**CANTERBURY EARTHQUAKE  
RECOVERY AUTHORITY**

**ACCESSIBILITY AUDIT  
VICTORIA SQUARE  
AVON RIVER  
CHRISTCHURCH**

**EXISTING SQUARE  
SITE AUDIT**

#### 7.1.4 RAMP TO HAMISH HAY BRIDGE

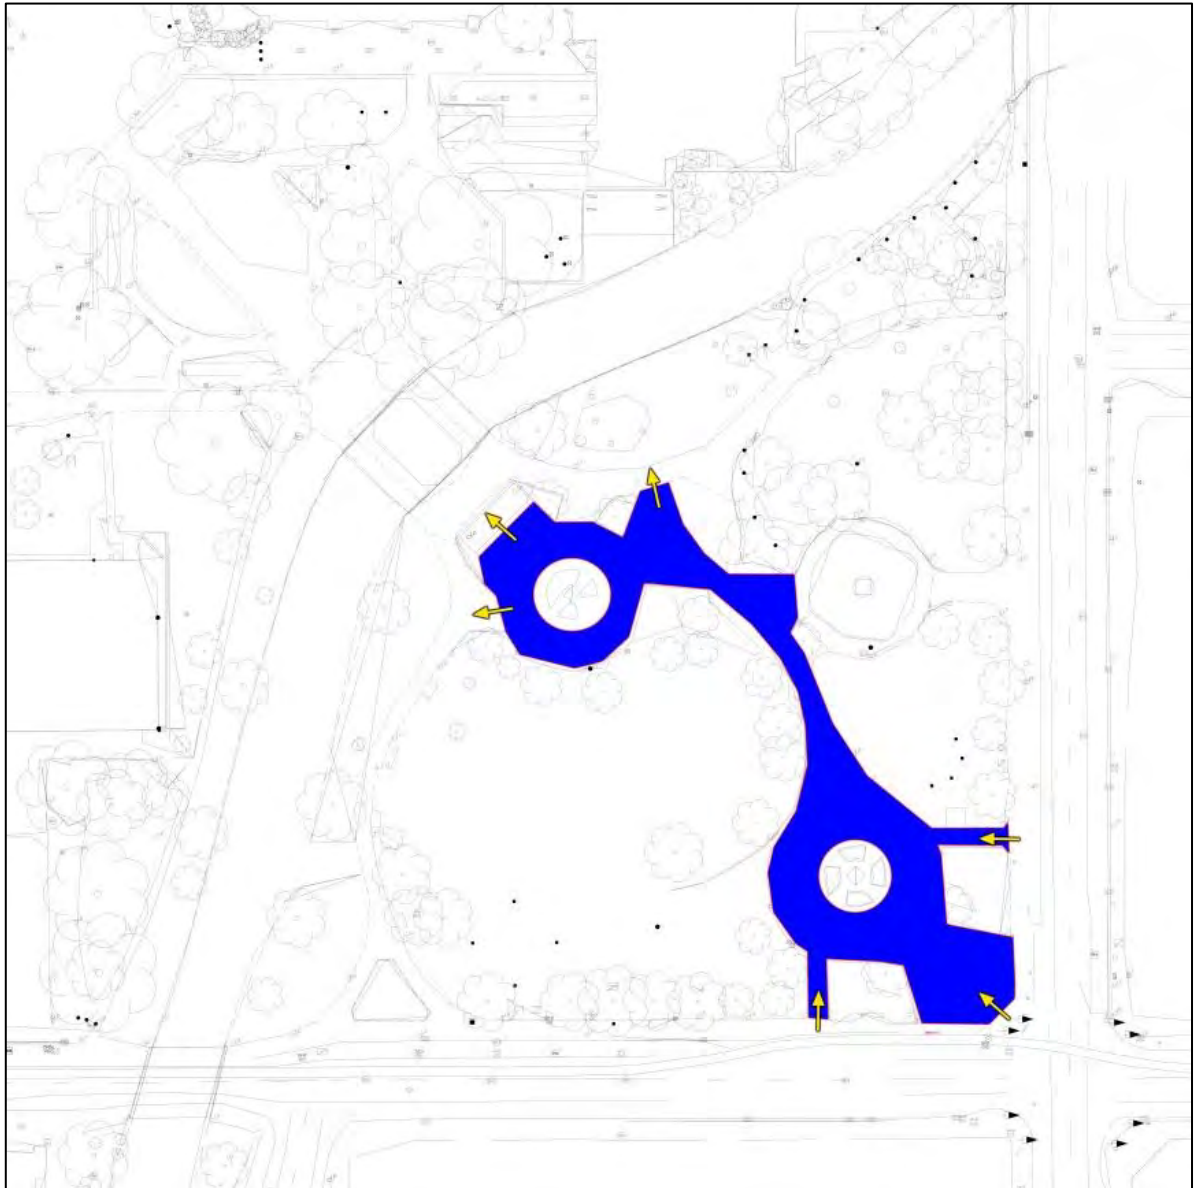
- The ramp has a traverse slope (cross fall to the western side)
- The ramps longitudinal gradient was averaged at a non-accessible 1:8.5
- No handrails are present either side of the ramp.

- There is potential to increase the elevation of the pathways leading to the ramp to create an elevation increase at the base of the ramp of approximately 490mm. This would enable a gradient of 1:20 to be possible and eliminate the need for handrail provision.

### 7.3.3 RAMP TO HAMISH HAY BRIDGE

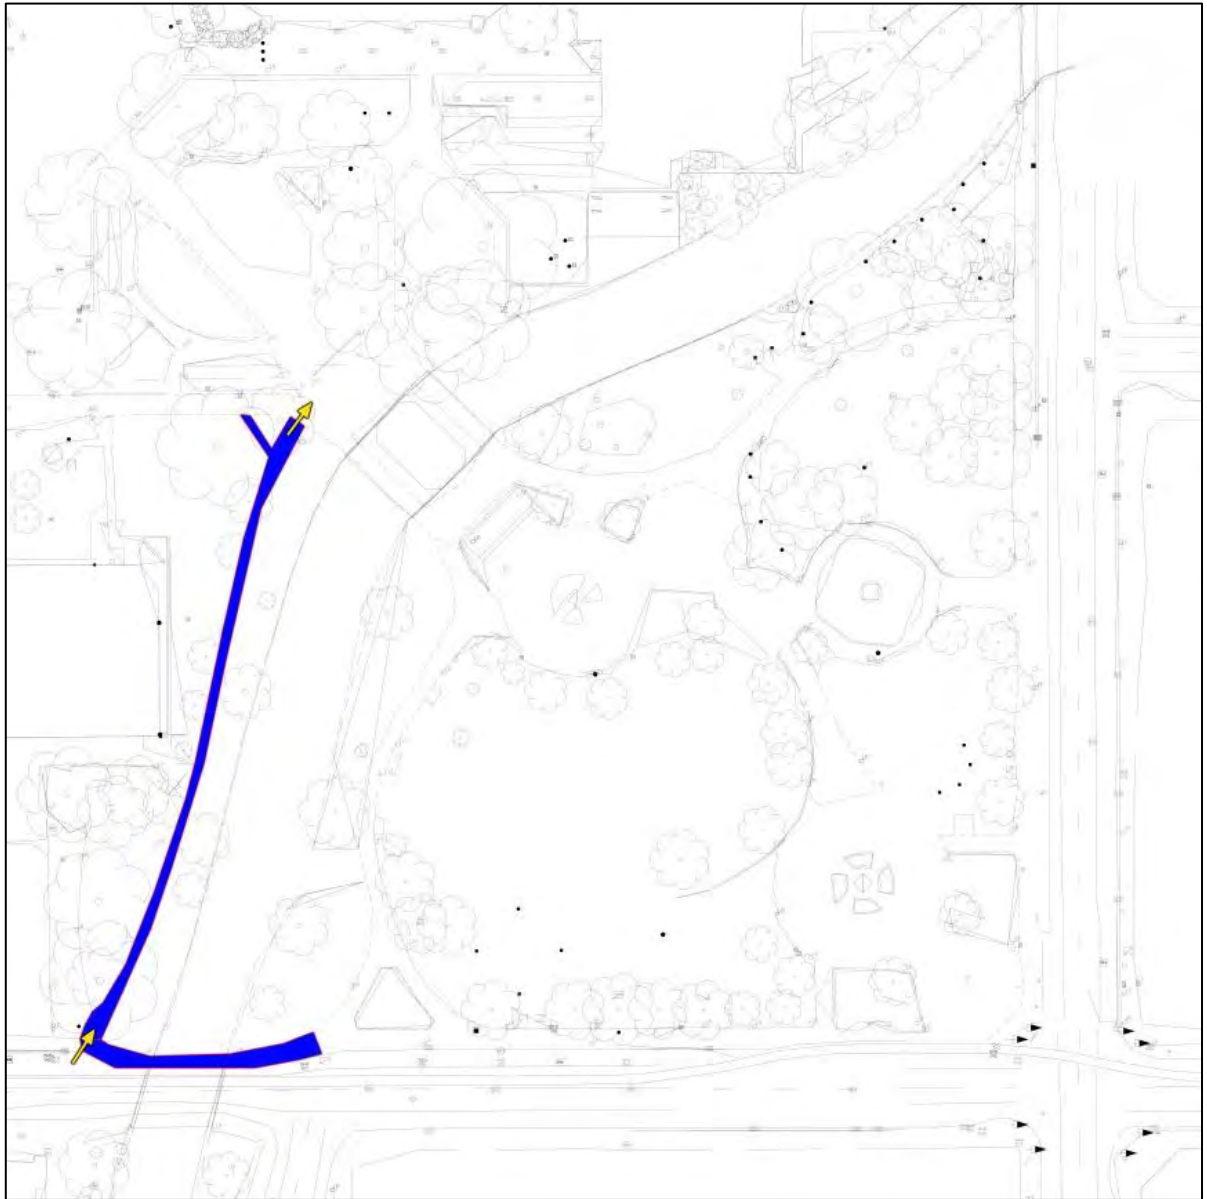
- The ramp has a traverse slope (cross fall to the western side).
- The ramps longitudinal gradient was averaged at a non-accessible 1:9
- No handrails are present either side of the ramp.

- There is potential to increase the elevation of the pathways leading to the ramp to create an elevation increase at the base of the ramp of approximately 490mm. This would enable a gradient of 1:20 to be possible and eliminate the need for handrail provision.

#### 7.4.5 ALTERNATE PATHWAY EXIT (NORTH END) TO CHESTER STREET WEST

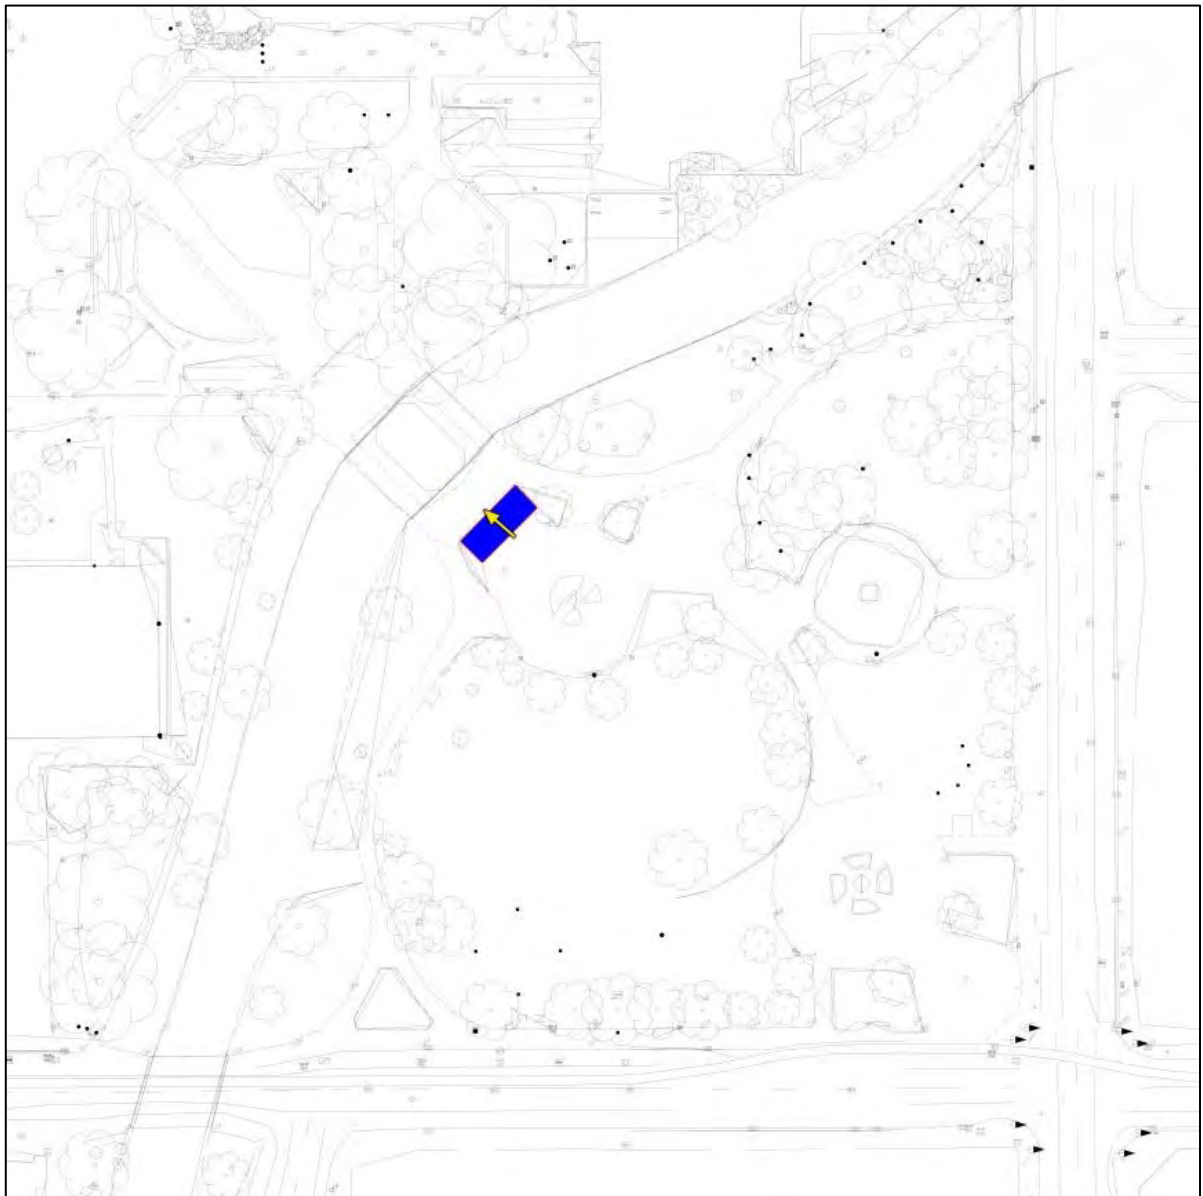
- The ramp was a non-accessible gradient of 1:9.5 and has no handrails on both sides.

- This ramp provides an alternate connection at the northern end of route 4. Therefore provided that the main pathway of route 4 was made accessible including the connection to the Hamish Hay Bridge then this alternate pathway could remain 'as is' due to the main route 4 pathway connecting to effectively the same place (other side of tree) on the pathway to Chester Street West.

## 7.5.1 SOUTH SIDE STAIRS TO HAMISH HAY BRIDGE

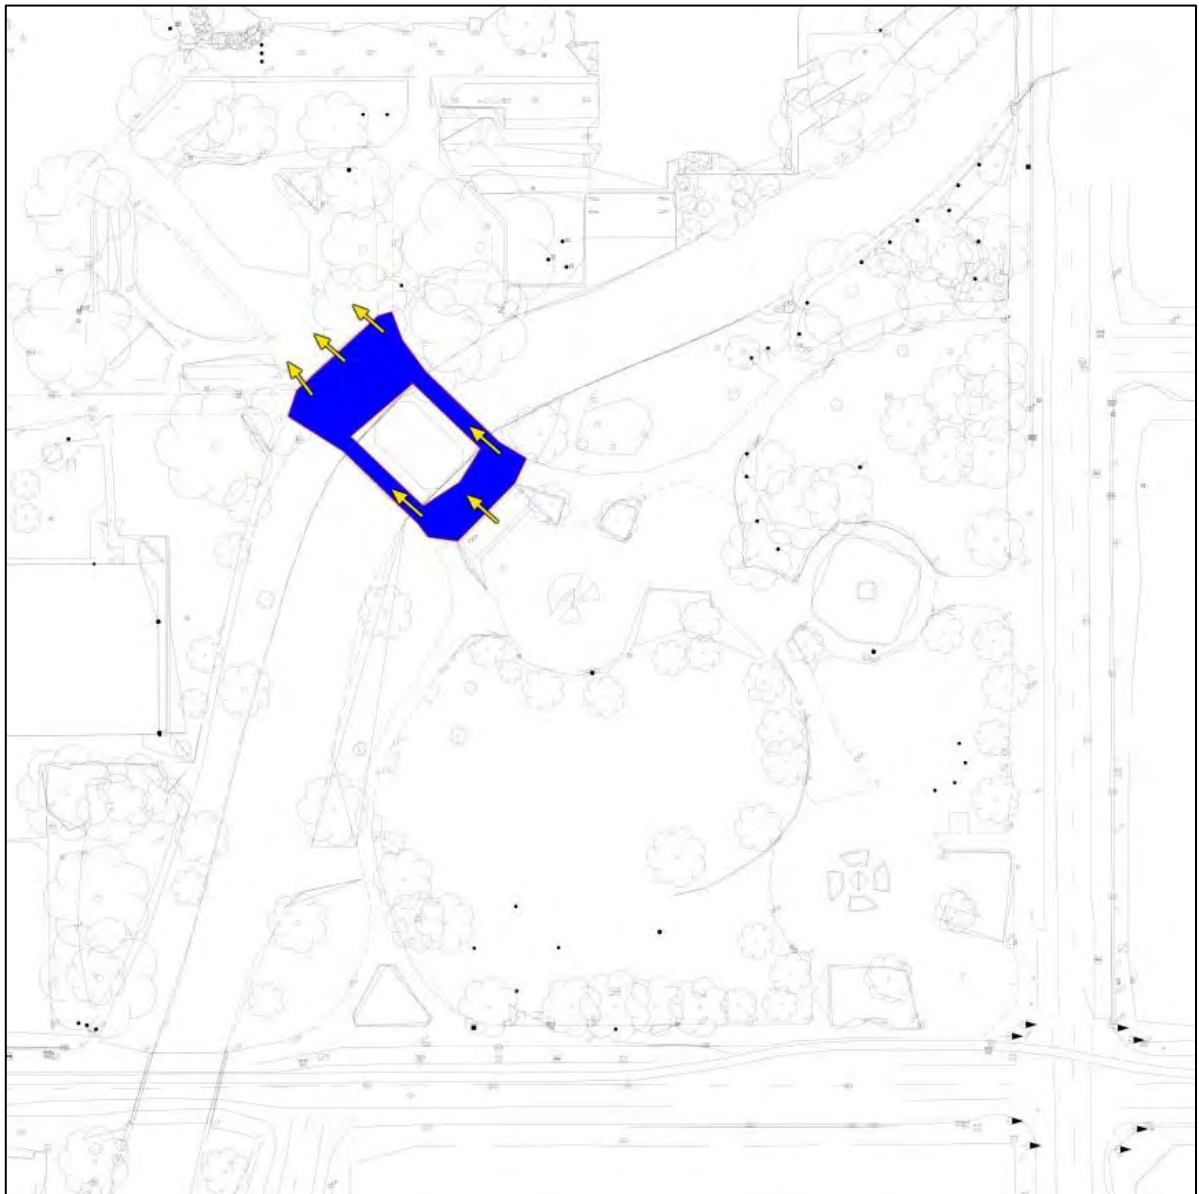
- The riser height varied between 140-160mm. Accessible stairs must have consistent riser heights.
- The handrail lacked extensions of 300mm past the top riser, and 300mm plus one tread length past the bottom riser.
- For a stairway that has a total width of 13m handrails should be provided at both ends in addition to a central handrail.
- No contrasting nosings were present on the stairs.
- The nosing projected 30mm in some places (others it was flush) this projection creates a trip hazard.
- The front edge of the tread was not rounded.
- The contrast was poor between the surrounding routes and the stairs.

- Ensure that the stair risers are a consistent height.
- Install additional compliant handrails at each end of the stair.
- Replace the existing central handrail with one that meets today's standards (extensions etc).

- Incorporate contrast of colour at the top and bottom of each stair flight.
- Incorporate a contrasting nosing strip into the stair treads.

### 7.7.3 RIVERSIDE PATHWAY

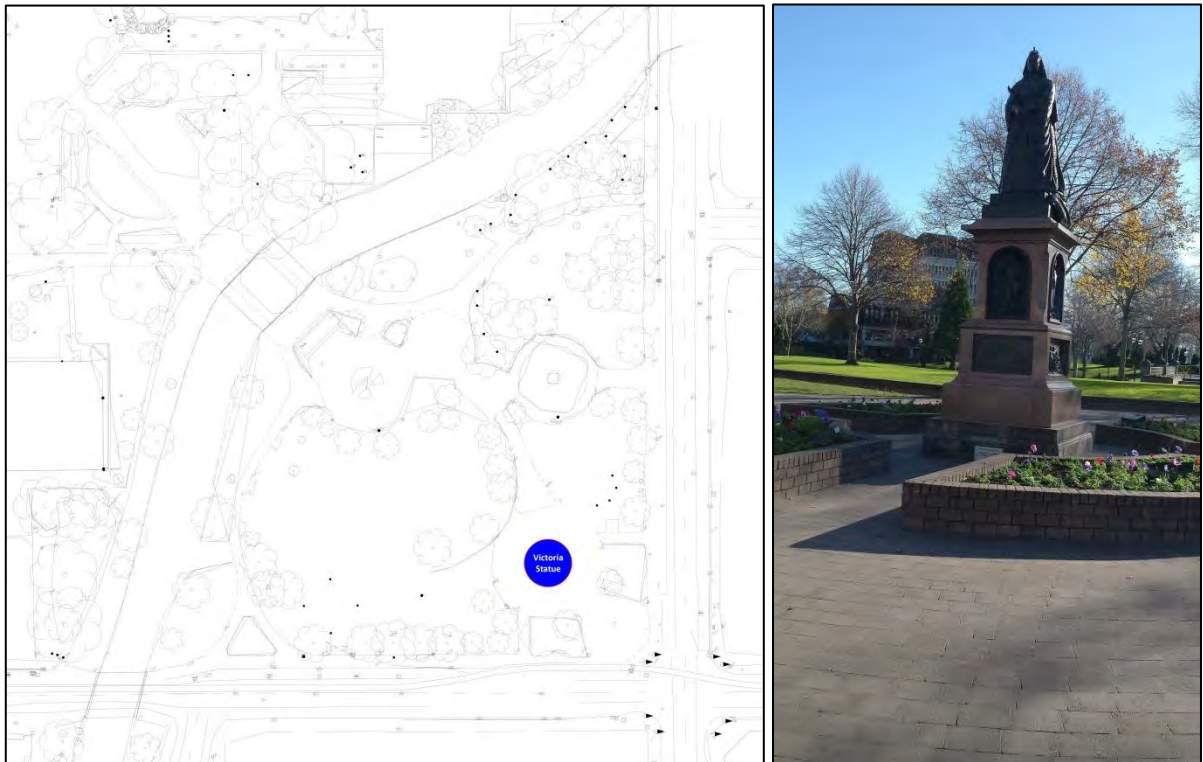
- The surface is loose metal, and uneven in many places.
- The width of the pathway is 1200mm wide at its widest point, and 1000mm at its narrowest.
- No upstand on river edge of path.

- Resurface the metal path with an asphalt or concrete surface.
- Increase the pathway width to 1500mm (ideally 2.0m+)
- Consider inclusion of recessed seating areas off to the side of the path which would provide a safe and level platform outside of the pedestrian flow for relaxing and taking in the view for wheelchair users, persons with mobility aides and parents with strollers.
- Install an upstand of 75mm along the river edge side of the path to prevent wheelchairs, prams etc running/tipping over the edge into the Avon River.

## 7.9.2 ACCESS PATHWAYS AROUND STATUE

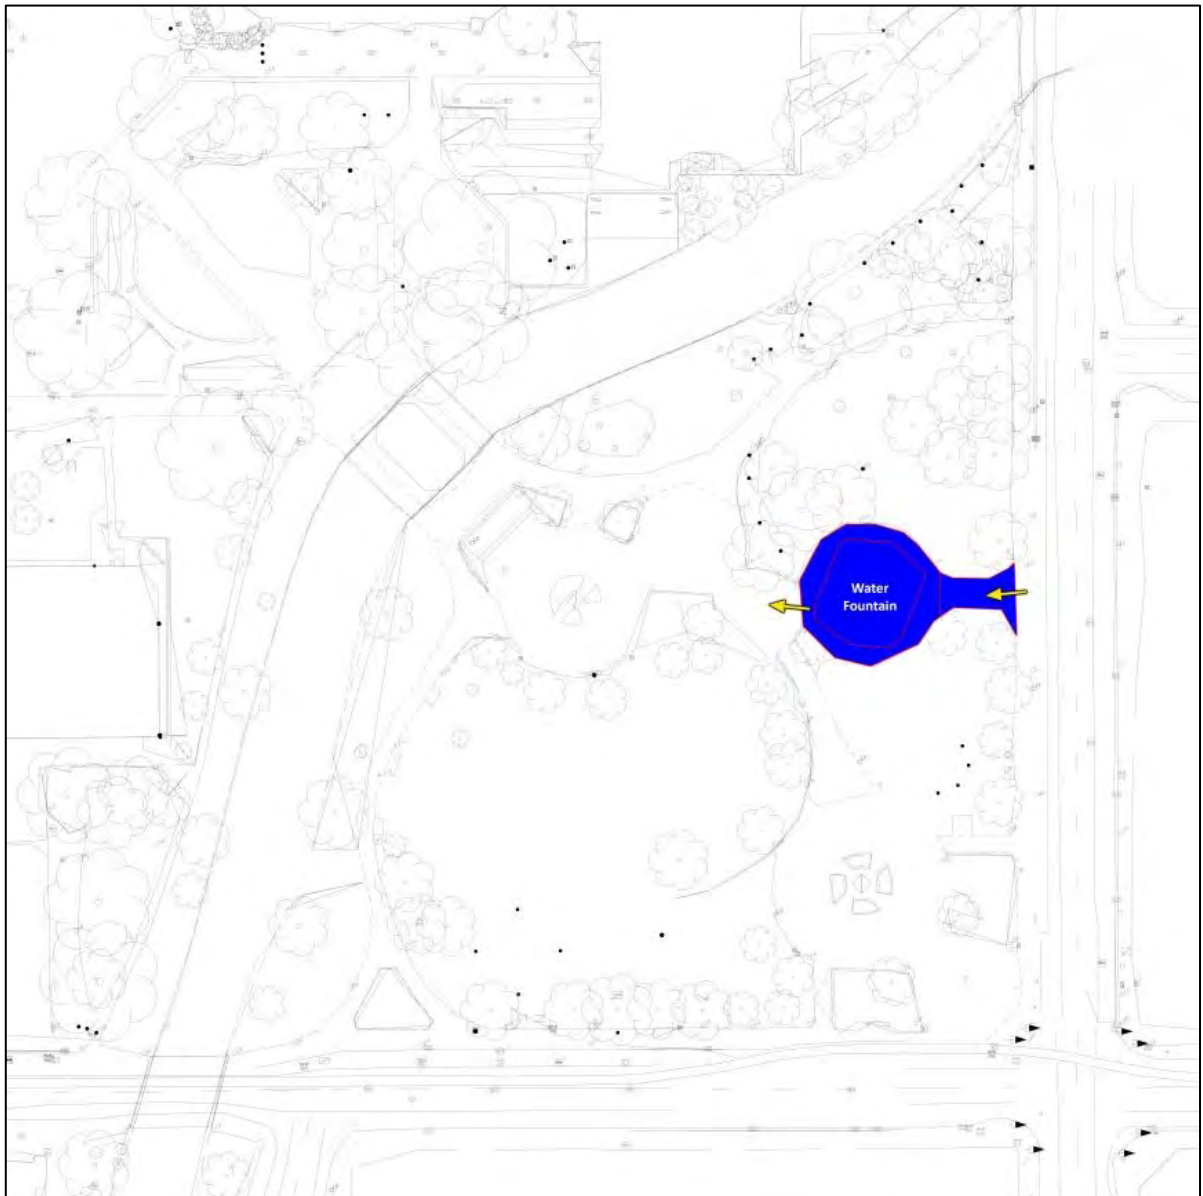
- The clear width of the circulation spaces around the statue at their narrowest point are between 510-590mm. This means a wheelchair user, or two ambulant persons coming from opposite directions would be unable to circulate the statue.

- Take the design approach used by the Victoria Statue and make the internal corners of the garden curved rather than square. Ensure a clear width of 1200mm is achieved at the tightest points.

## 7.11.1 PICNIC AREA

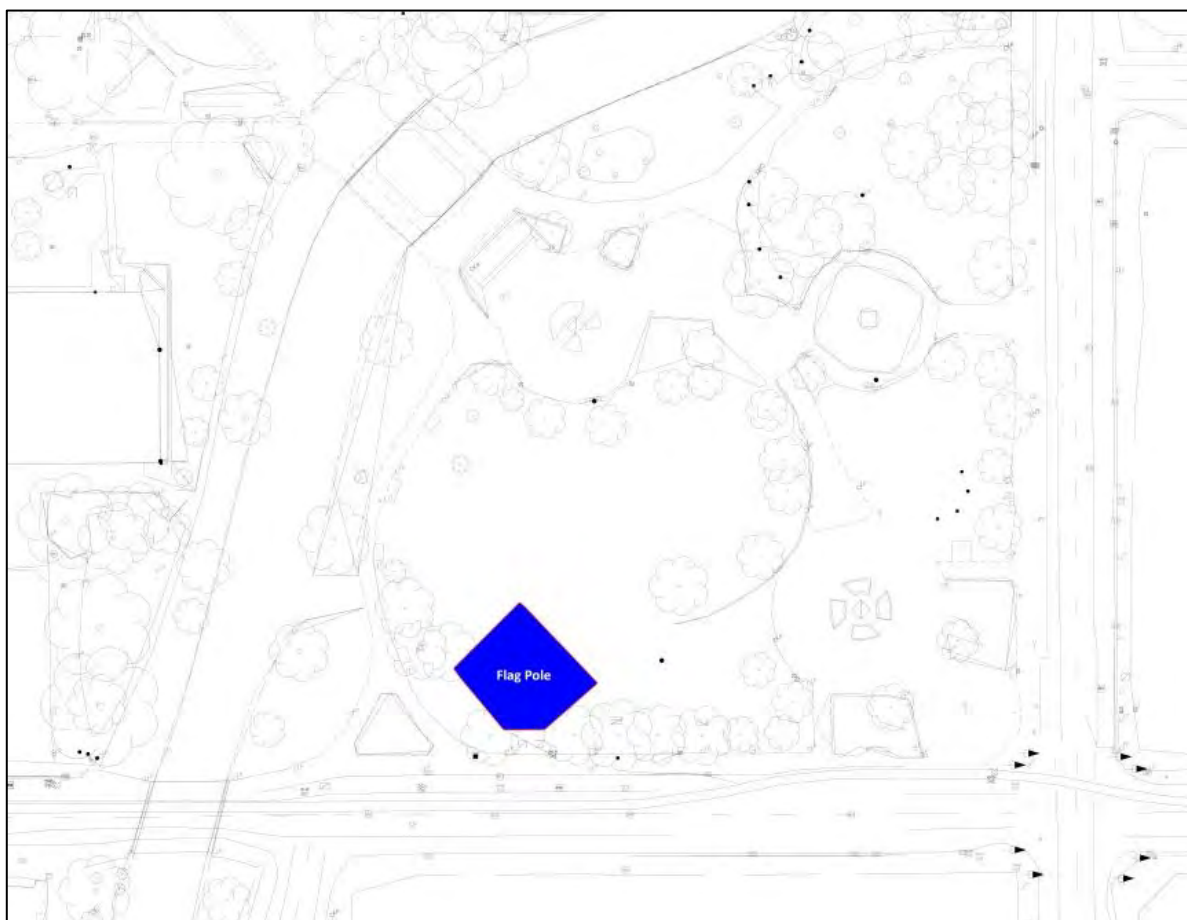
- The low fixed seating may prove difficult for the elderly or persons with limited strength/mobility to sit in and get back up.
- The ground surface is sloped down towards the footpath which may affect balance, or catch wheeled mobility aides off guard upon reaching the table.

- We understand that all seating and tables in this area are likely to be replaced; we see this as an opportunity to create some universally accessible furniture and gathering areas at Victoria square which will cater for a wide range of persons regardless of ability well into the future.
- Seating should be provided to accommodate all persons regardless of ability. For elderly people the preferred seat height is 520mm, for children and small people the preferred seat height is 350mm, and for general use a seat height of between 400-450mm is preferred. Typically seating should be mixed height in each location it is placed to cater for mixed groups of people to sit together.

## 7.12.1 FLAGPOLE GENERAL

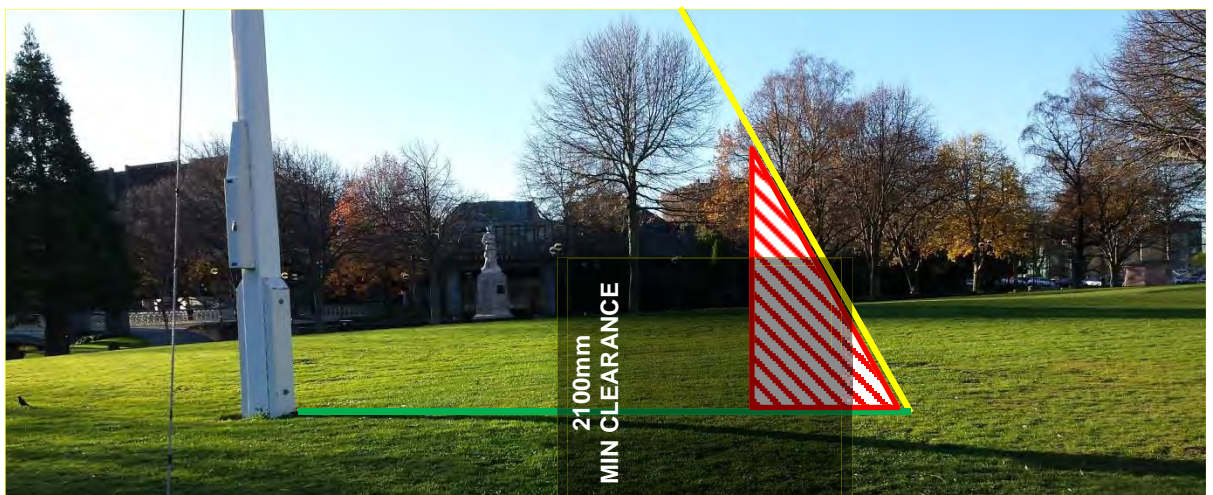
- The support lines for this flagpole are not contrasting to their surrounds, and are not protected at ground level. They could be considered as a dangerous projection for persons with low vision or blindness.
